## **NOTICE OF PUBLIC MEETING**

**Governmental Body: Van Meter Planning and Zoning Commission**

VAN METER, IOWA  
GRAND RIDGE ESTATES TOWNHOMES  
PRELIMINARY PLAT/SITE PLAN  
REVIEW COMMENTS

**RE: Grand Ridge Estates Townhomes Plat 1 – Preliminary Plat / Site Plan**

**WATER MAIN PLAN & PROFILE**

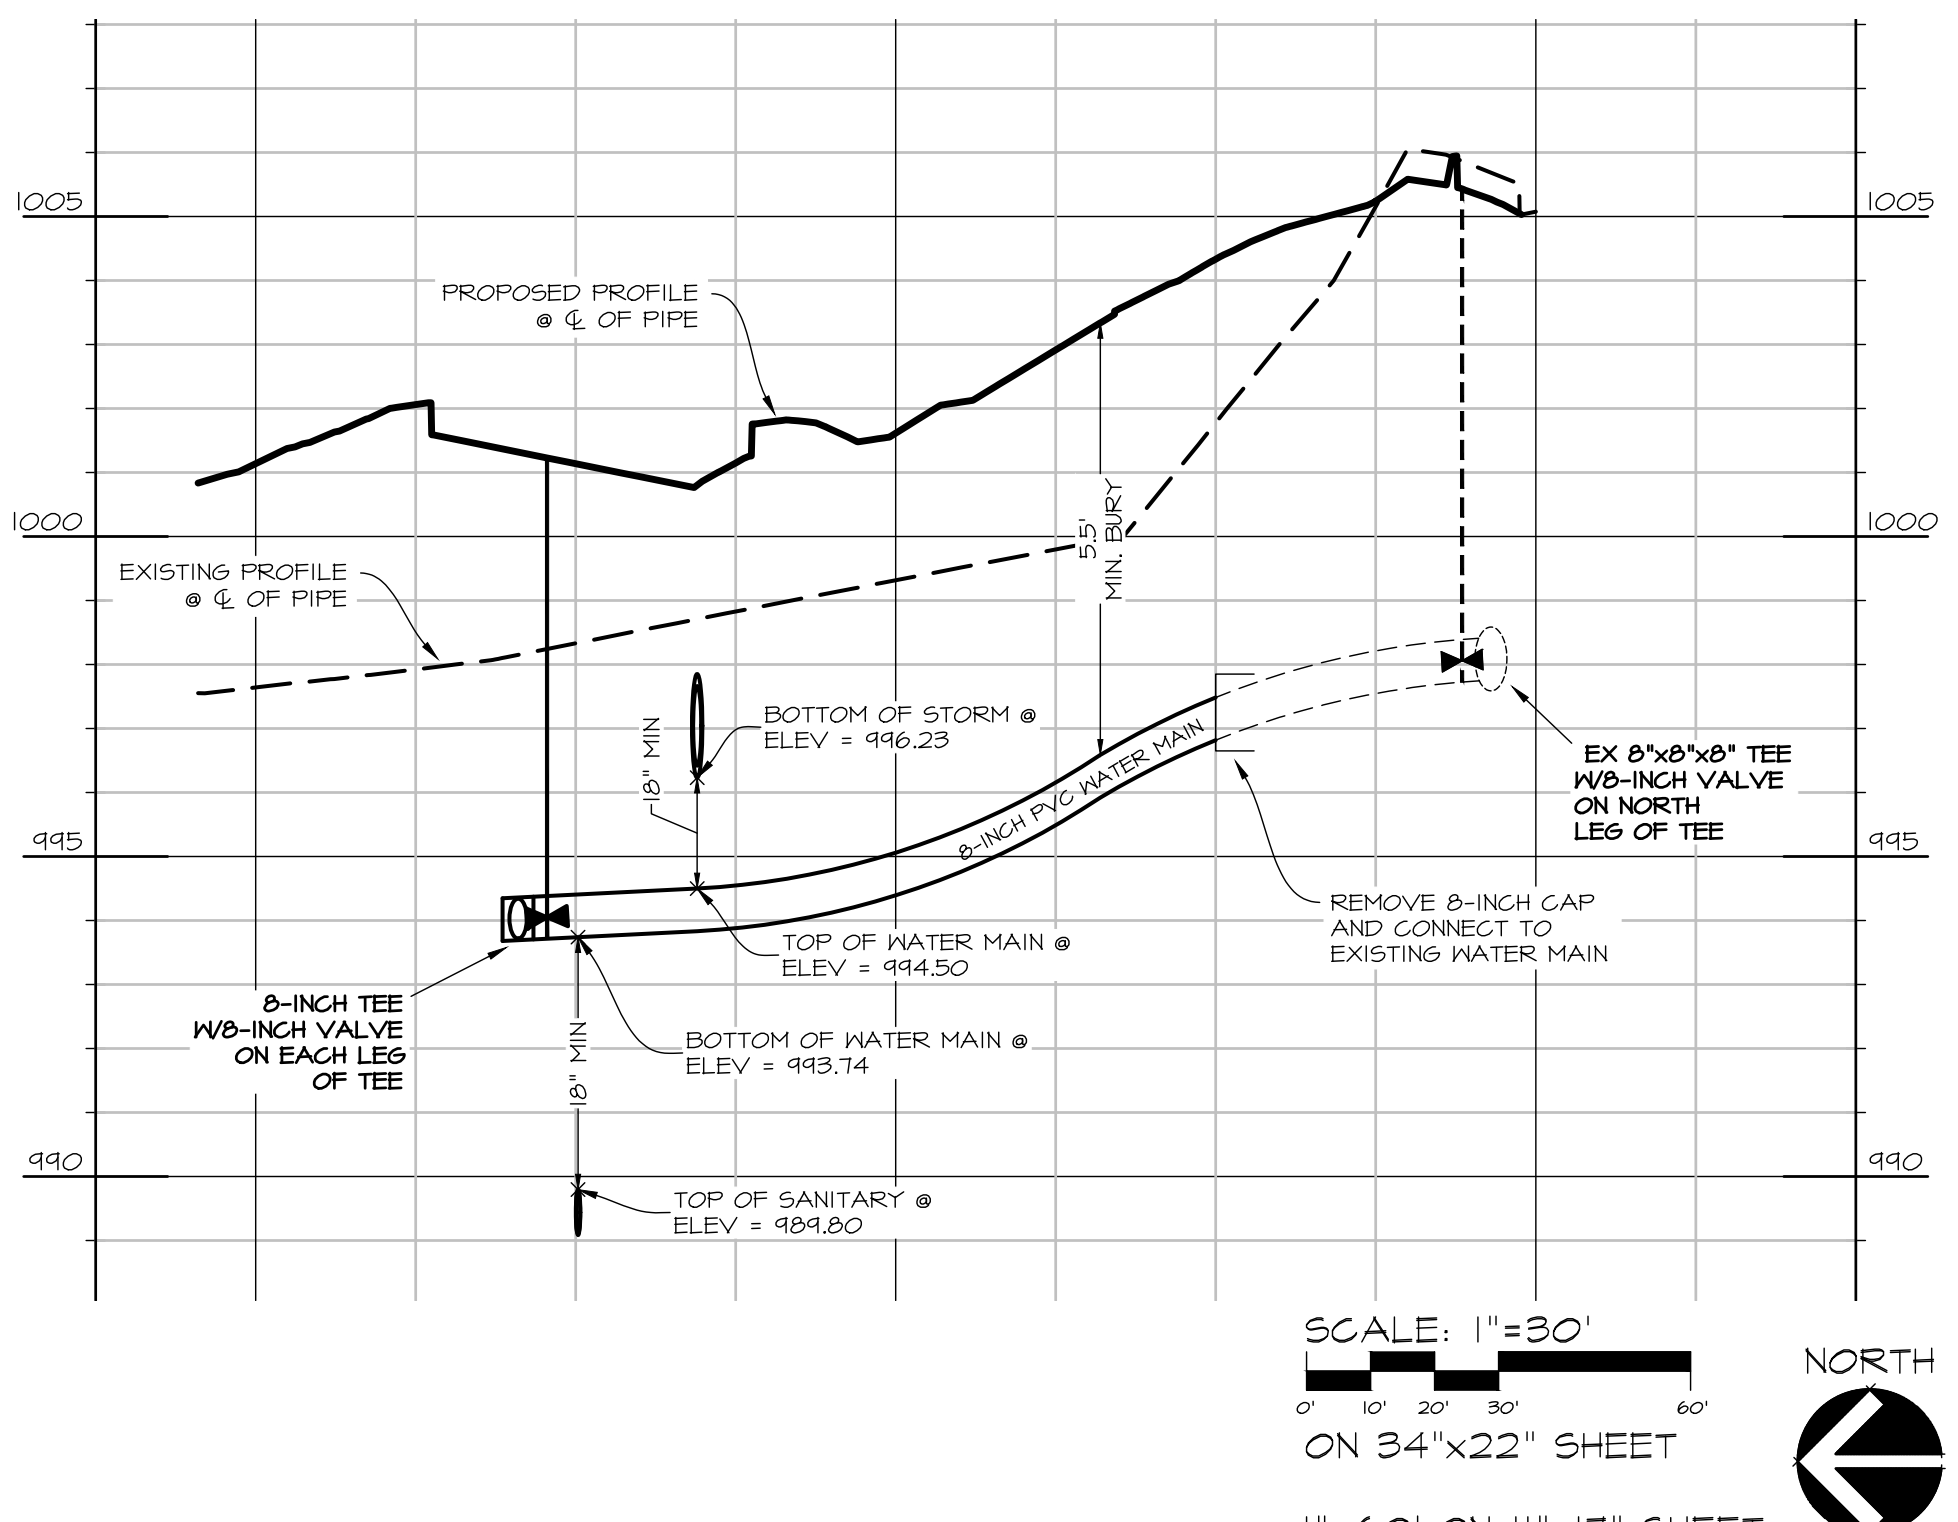
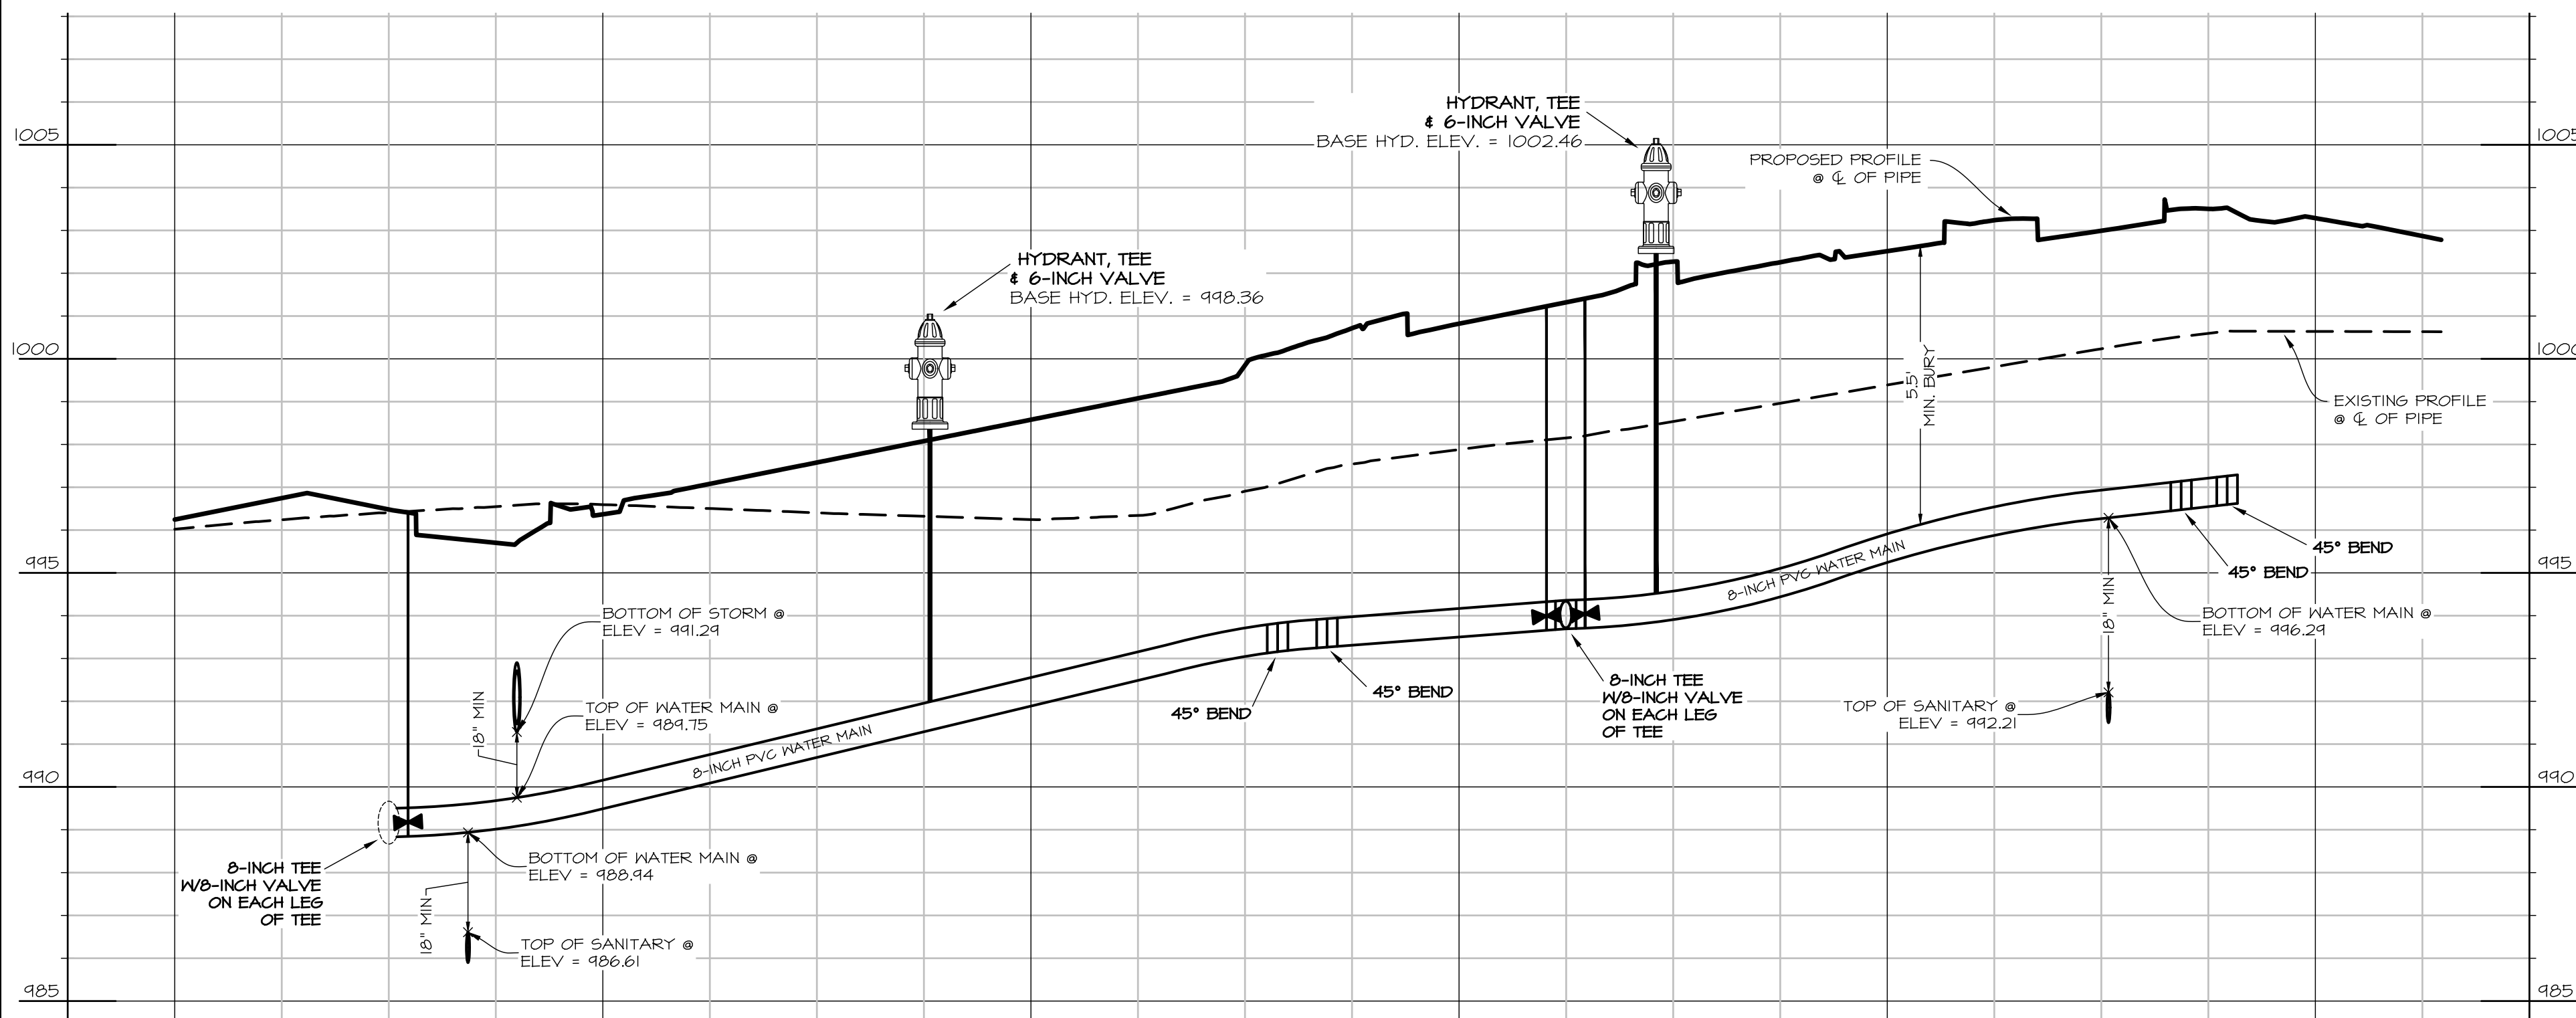
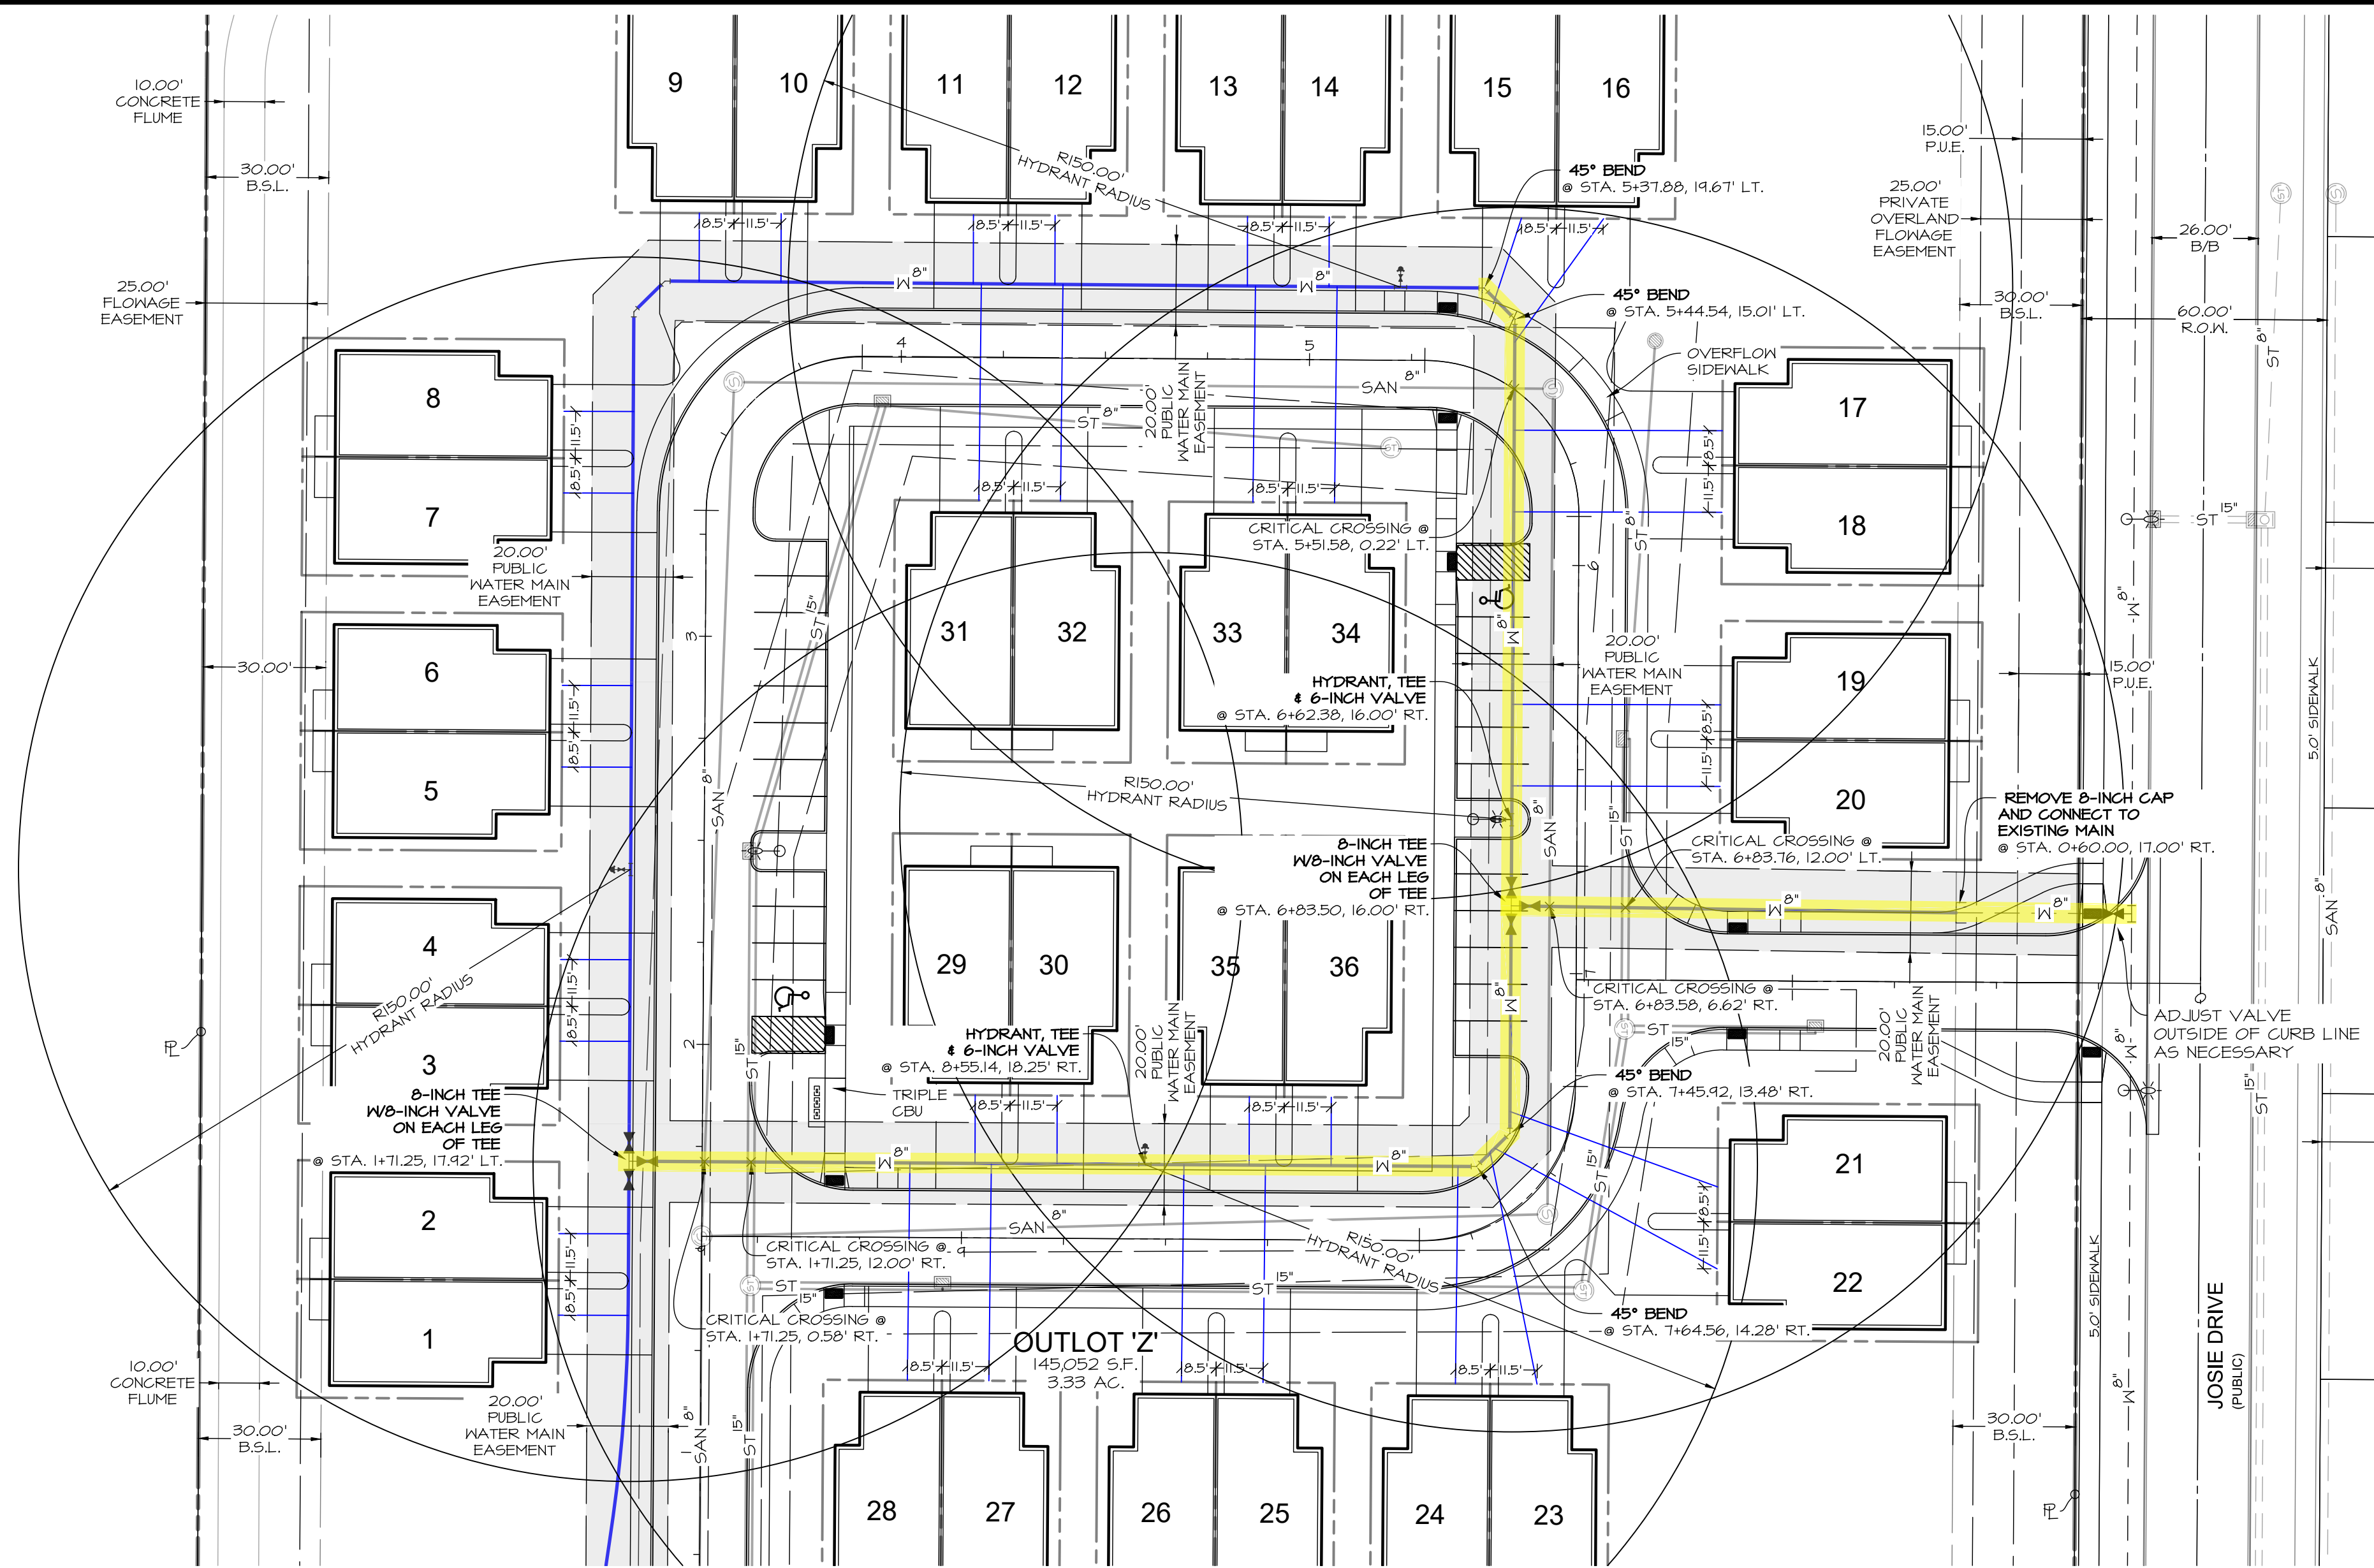
30. The internal loop of the water main includes two tee connections. Currently valves are shown on the two legs of the southwest tee and one leg of the east tee. It is recommended valves be provided on all three legs of the tee in order to provide enhanced isolation.

30. Valves have been added on all three legs of the water main of the two internal tees to provide enhanced reliability of the water system. The additional valve locations are satisfactory.
34. MPE elevations are now shown for all lots.

29. The site plan shows hydrant coverage circles. The hydrant coverage is satisfactory. **OK**
30. The internal loop of the water main includes two tee connections. Currently valves are shown on the two legs of the southwest tee and one leg of the east tee. It is recommended valves be provided on all three legs of the tee in order to provide enhanced isolation. **Additional valves have been added at the tee connections.**
